Item 2
36 Olive Street, Ryde - LDA2021/0308
Construction of a new two storey dwelling
Report prepared by: Development Assessment Officer

**City of Ryde
Local Planning Panel Report**

DA Number	LDA2021/0308
Site Address & Ward	36 Olive Street, Ryde Lot 62 DP 26696 Central Ward
Zoning	R2 Low Density Residential
Proposal (as amended)	Construction of a new two storey dwelling
Property Owner	Hoon Cho & Catherine Sook Min Cho
Applicant	Platinum Solutions
Report Author	Oliver King – Development Assessment Officer
Lodgement Date	8 September 2021
Notification - No. of Submissions	<ul style="list-style-type: none"> • Five (5) submissions received objecting to original plans. • Nine (9) submissions received objecting to amended plans.
Cost of Works	\$950,523.00
Reason for Referral to LPP	Contentious development – is the subject of 10 or more unique submissions by way of objection.

Figure 14 - Plan showing the side setbacks of the proposed dwelling as shown in red circles.

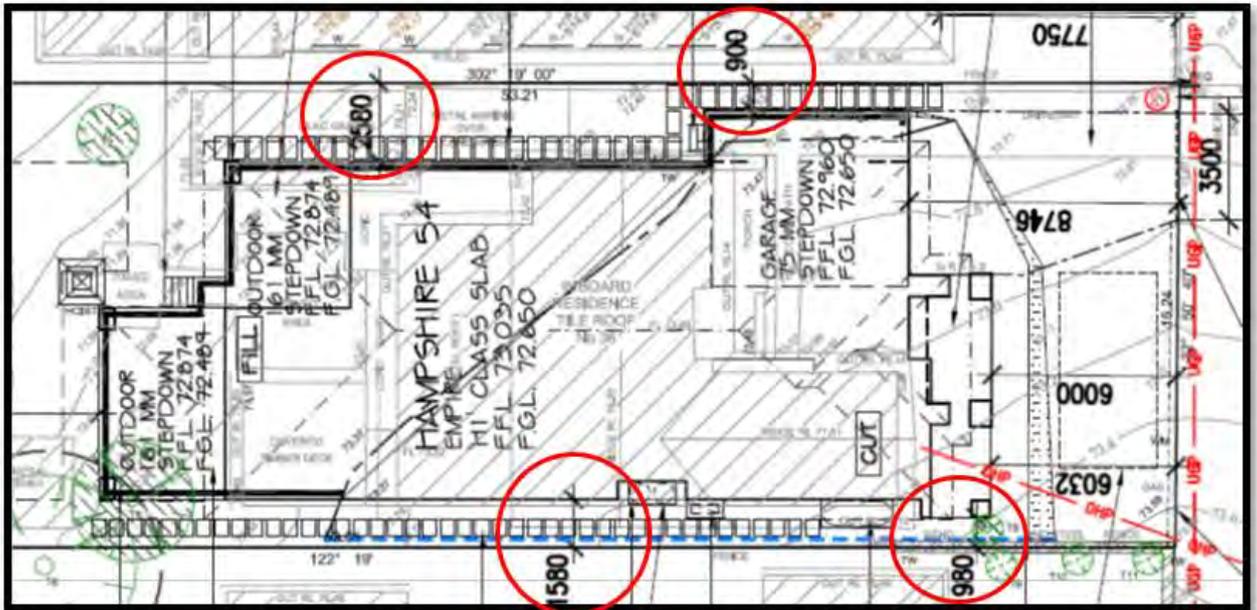
The proposal does not comply with the required ground floor setback of 1.5m. **Figure 14** shows the areas that breach the setback requirement.

This non-compliance is considered acceptable for the following reasons:

Figure 15 – Proposed South-West elevation showing sitting room window (red) and family room window (blue).

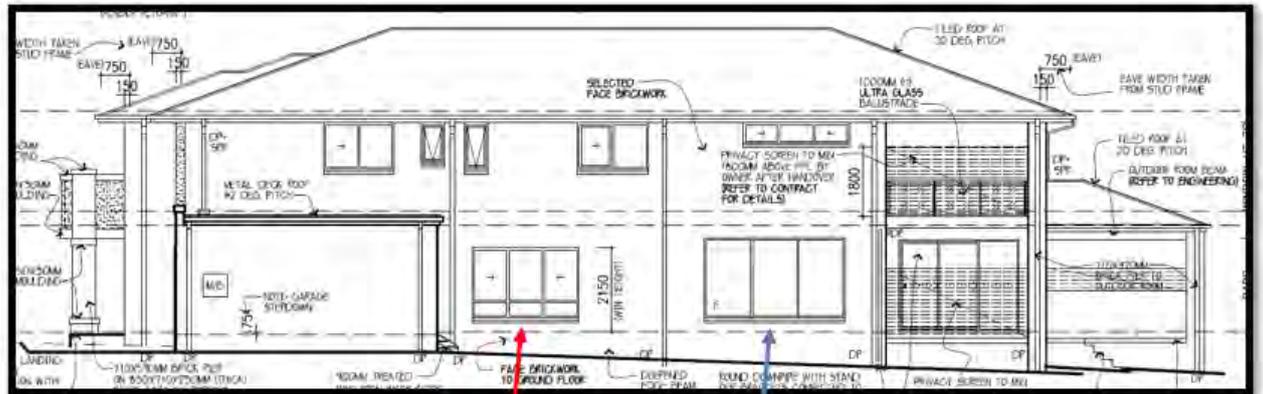
Comment: The sitting room window and family room window on the South-West elevation are both large in size. As the ground floor in the vicinity of these windows will be elevated above NGL, there is the potential to allow for overlooking to the adjoining dwelling at No. 38 Olive Street. The windows are assessed in detail below:

Sitting Room window. The sitting room window is large in size, is located in a high-use living area and has a finished floor level approximately 600mm above the adjoining NGL. Further to this as the site plan shows, the sitting room will allow for direct sight lines to the adjoining dwellings windows. To protect the visual privacy of the adjoining neighbours at No. 38 Olive Street, the following condition has been placed on the consent:

- **Figures 15 – 18** show that the living room window will be located adjacent to the high-sill rumpus room window at No. 38 Olive Street, Ryde. As per the amended survey plan provided by the applicant and shown in **Figure 16**, the rumpus room window has a sill height of RL75.56 and top window height of RL76.17. The proposed finished floor level of the family room is RL73.28. An individual standing in the family room will therefore have an approximate sightline 1.6m above the FFL, resulting in an RL of RL74.88. This means that the eye height of an individual standing at this window will be 680mm lower than the sill height of the adjoining rumpus room window at No. 38 Olive Street. As such, there will be minimal overlooking to the adjoining rumpus room window from this location.

- **Sitting Room window.** To protect the visual privacy of the adjoining dwelling, the sitting room window (as shown on Elevation D/South-West Elevation) is to be amended in one of the following ways:
 - a) Obscure glazed glass is to be used in the entire window;
 - b) The window is to be constructed as a high sill window with a sill height of 1.6m above the finished floor level;
 - c) A privacy screen is to be attached to the window to a height of 1.6m above the finished floor level which will prevent residents from being able to view directly towards 38 Olive Street.

The architectural plans are to be amended prior to the issue of the **Construction Certificate** to demonstrate which option is proposed for this window.

Figure 16 – Proposed site plan and sitting room window (red) and family room window (blue) in relation to adjoining windows at No. 38 Olive Street.

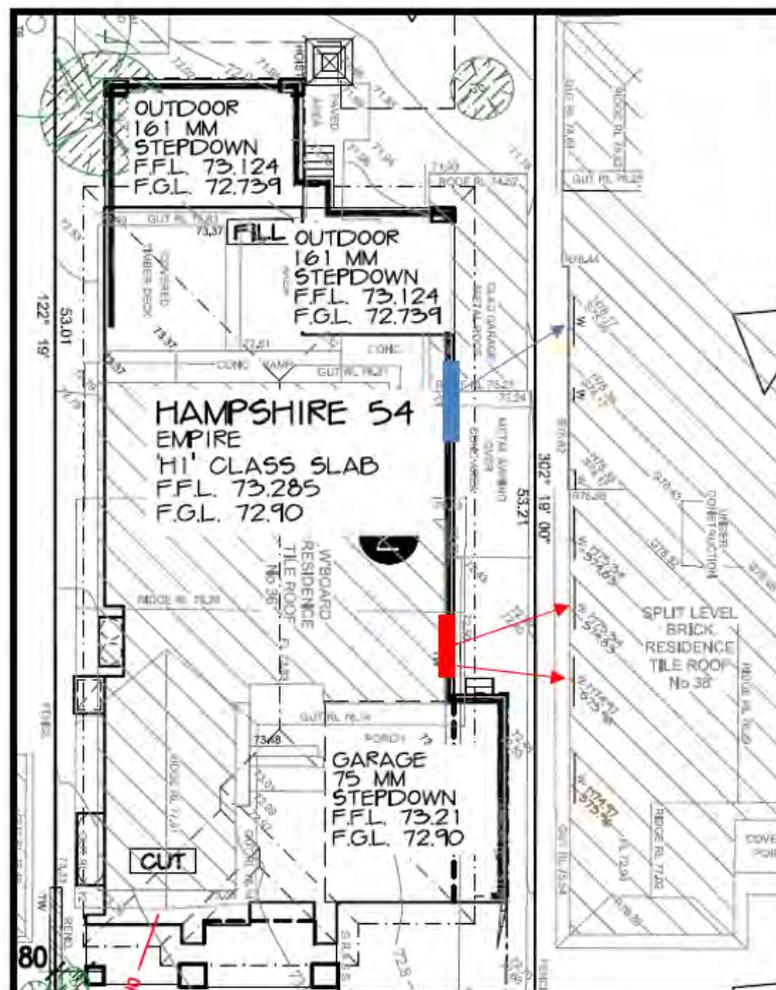
- As the below **Figure 16** shows, due to the location of the window, the lines of sight from the proposed family room will not infringe upon the visual privacy of the bedrooms at No. 38 Olive Street.

Figure 25 – Ground floor space calculation totalling 144.4m².

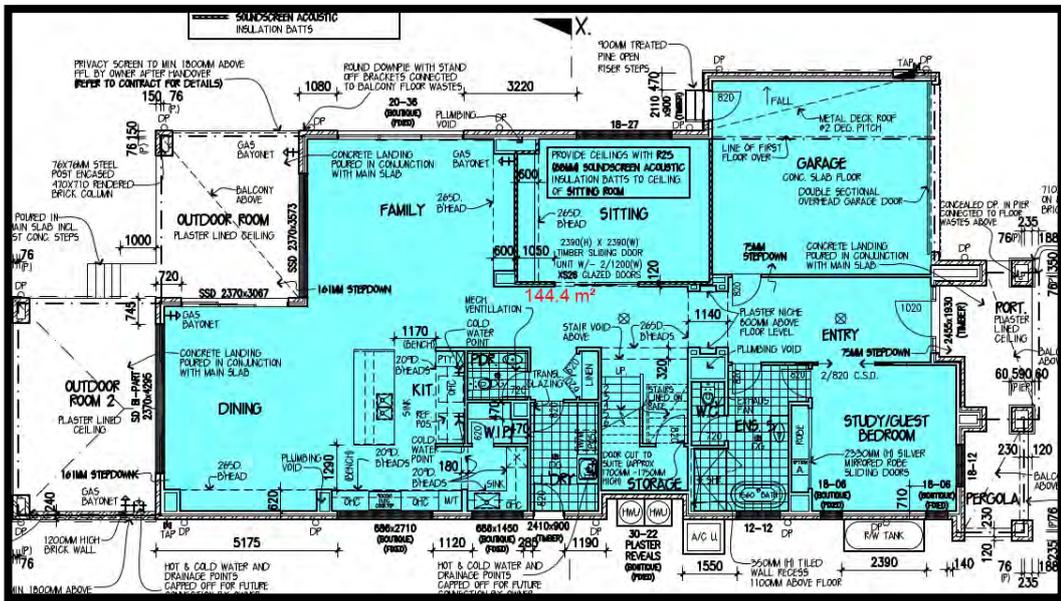
(b) Floor Space Ratio (FSR). Concerns were raised from objecting neighbours that the floor space ratio of the development was non-compliant with Council’s controls.

The proposed floor space totals the ground floor (144.4m²) plus the first floor (208.4m²) minus the 36m² credit given for a double garage. This results in a total floor space area of 316.8m². As such, the floor space ratio (316.8m² divided by the site area being 809.4m²) totals 0.39:1 which complies with the above maximum 0.5:1 and is therefore supported.

Figure 29 – Sectional plan detailing proposed floor level (RL73.285) and adjoining NGL (RL72.415).

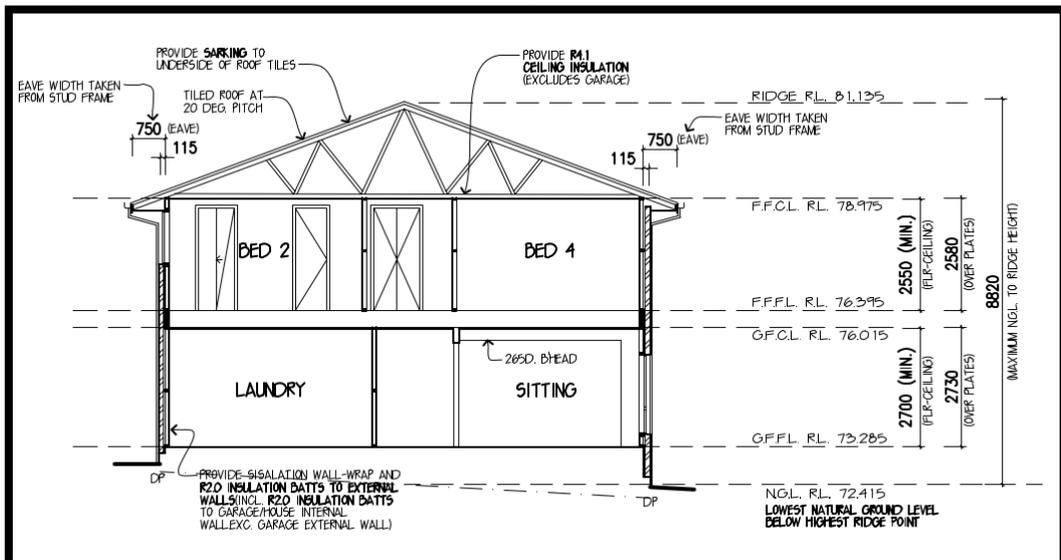
Comment: Council's DCP 2014: Part 3.3 - Dwelling Houses & Dual Occupancy (attached) – Section 2.6.2 '*Topography & Excavation*' states:

Figure 37 – Plan detailing degree of overshadowing caused by development between 9am and 3pm on June 21.

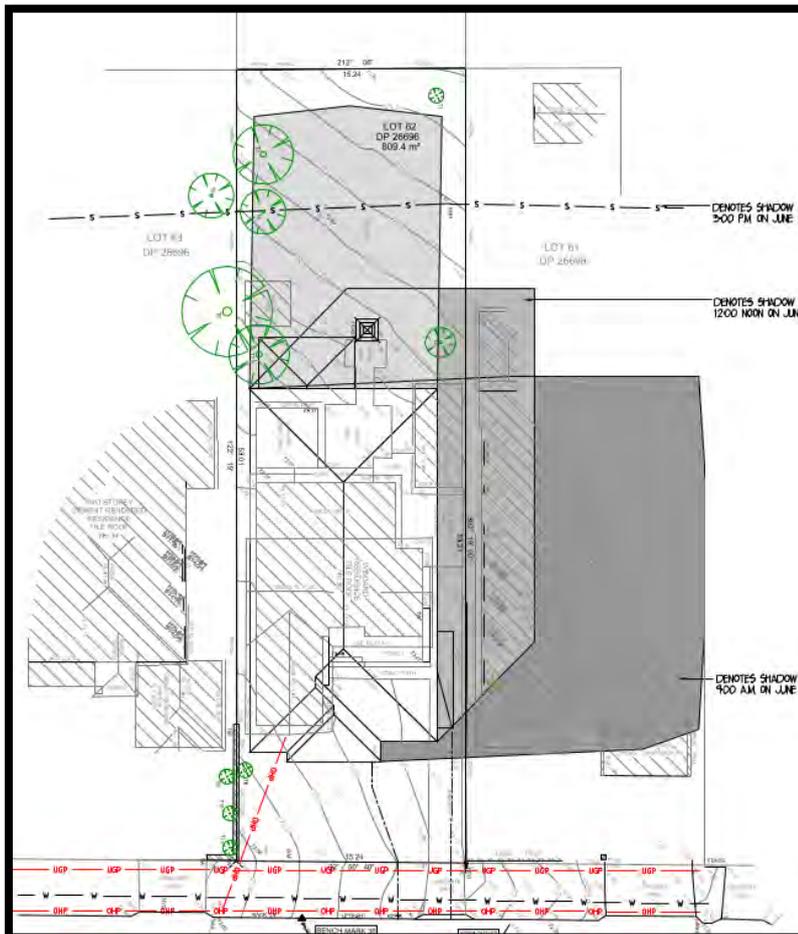
- The existing dwelling is a single storey structure with a new two-storey development being proposed. Due to the increase in number of storeys some element of additional overshadowing is inevitable from the sites existing state.

- The north-facing windows that are impacted by overshadowing to the adjoining dwelling at No. 38 Olive street are bedroom and bathroom windows, with the high-set rumpus room window receiving full sunlight from 1pm onwards. As such the north-facing living room window is compliant with the above control.

Figure 43 – Proposed Elevation C (South-East elevation) window layout.

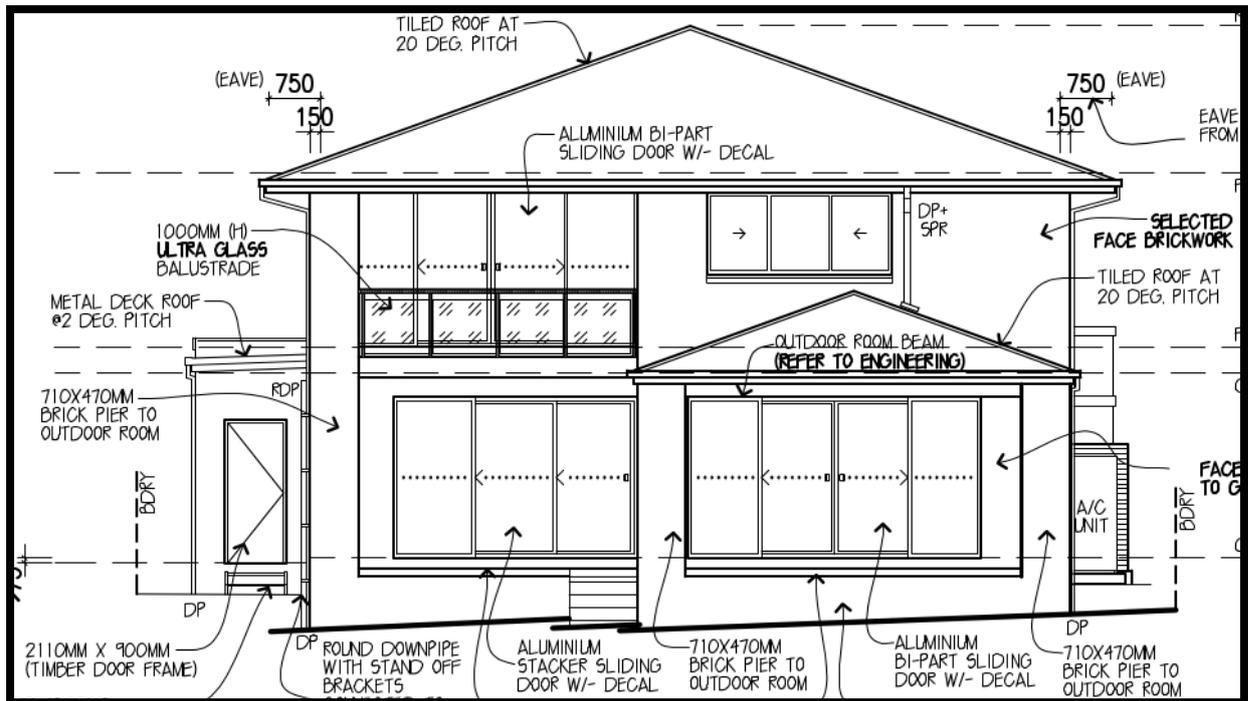
Ensuite 1 window. The ensuite 1 window is small in size. However as the plans do not indicate whether this window is to be obscurely glazed and due to the sensitive nature of this area, this window has been conditioned to be obscurely glazed on the development consent.

WC window. The WC window is small in size. However as the plans do not indicate whether this window is to be obscurely glazed and due to the sensitive nature of this area, this window has been conditioned to be fixed and obscurely glazed on the development consent.

Ensuite 4 window. The ensuite 4 window is small in size. However as the plans do not indicate whether this window is to be obscurely glazed and due to the sensitive nature of this area, this window has been conditioned to be obscurely glazed on the development consent.

Balcony 2. The external first floor balcony 2 is relatively large in size and significantly elevated above the adjoining NGL and dwellings. However, there will be no overlooking to the adjoining private open space of the dwelling at No. 38 Olive Street as the applicant has implemented a 1.8m high privacy screen from the finished floor level of this area.

Further to this, the balcony is located 22.05m from the rear boundary which is considered sufficient distance to reasonably obscure views to the rear adjoining neighbours at 37 Dorothy Street.

Figure 44 – Proposed landscaping plan with proposed rear yard planting to be re-located away from adjoining boundary.

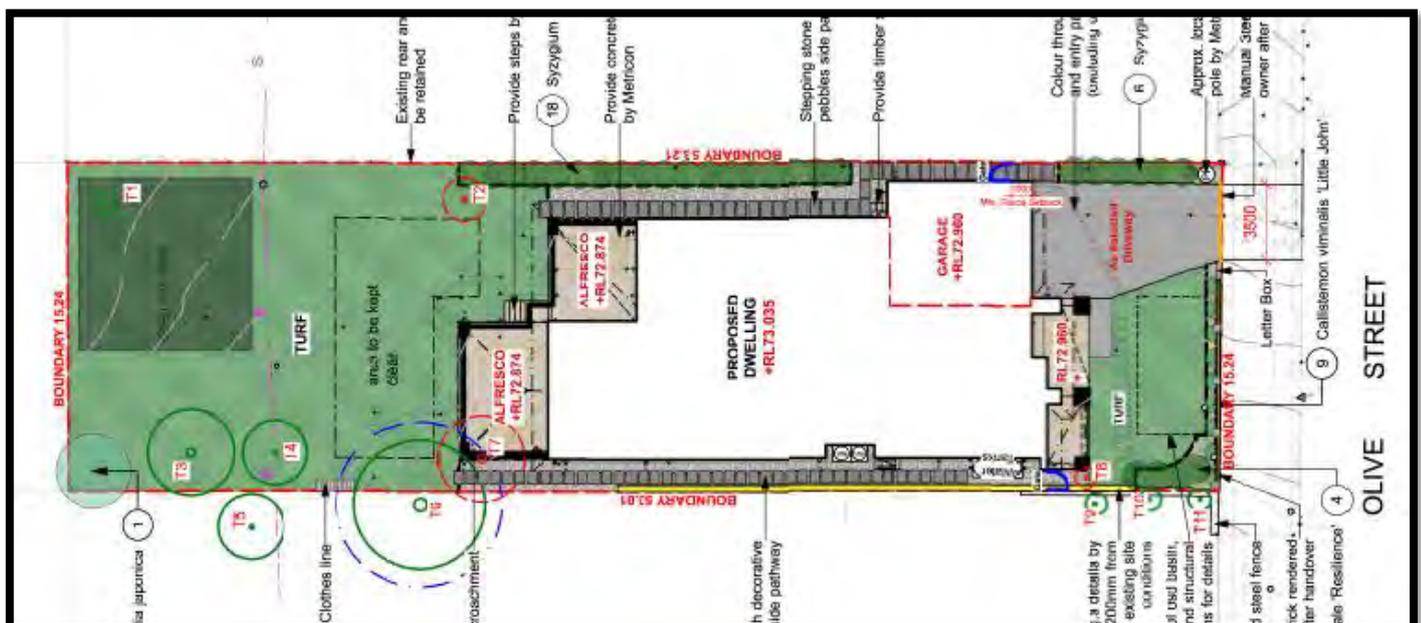
Further to the above comments, an amended landscape plan was received and notified to neighbours on the 14 January 2022 which detailed a steppingstone pathway between the front and rear setback to allow for navigable use of the site. Council’s Landscape Architect raised no objection to the four (4) proposed trees to be removed as a part of the application and as such the proposal is considered acceptable.

- (d) **Tree planting – location.** The Camellia Japonica tree is to be planted a minimum of 3m from any property boundary. The landscaping plan is to be amended accordingly.

Figure 45 – Proposed stormwater management plan detailing dispersal to Olive Street with rear absorption trench.

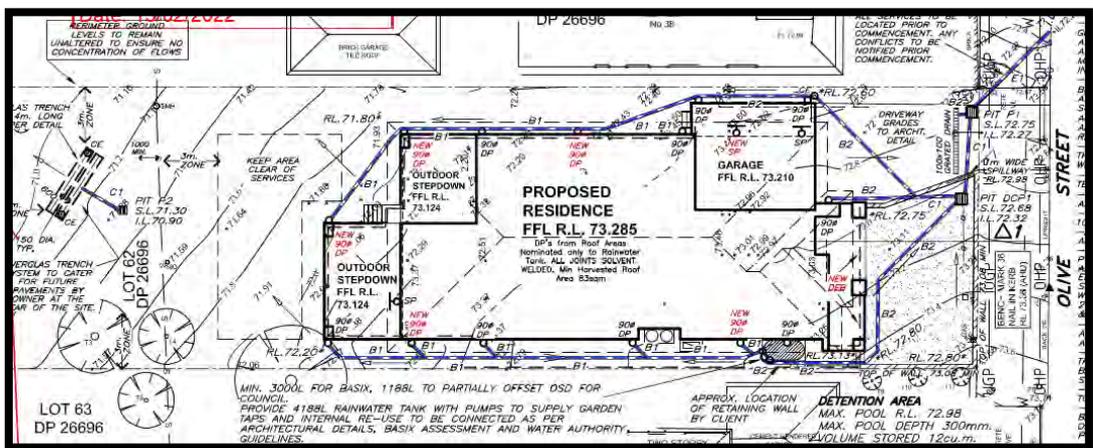
Comment: The proposal seeks a stormwater management plan dispersing the majority of the stormwater roof collection to OSD tanks in the front setback and onto Council’s stormwater system in Olive Street. The proposal furthermore seeks a rear absorption trench to prevent any down-stream runoff to the rear adjoining properties.

Council’s Development Engineer raised no objection to the proposed stormwater management method subject to seventeen (17) conditions that have been included in the draft consent attached with this report.

- provide site storage requirement (SSR) and permissible site discharge (PSD) design parameters complying with Council’s DCP 2014 Part 8.2 (Stormwater and Floodplain Management).
- incorporate a sump and filter grate (trash rack) at the point of discharge from the OSD system to prevent gross pollutants blocking the system or entering the public drainage service,
- ensure the OSD storage has sufficient access for the purpose of ongoing maintenance of the system, and

Detailed engineering plans and certification demonstrating compliance with this condition & Council's DCP 2014 Part 8.2 (Stormwater and Floodplain Management) are to be submitted with the application for a Construction Certificate.
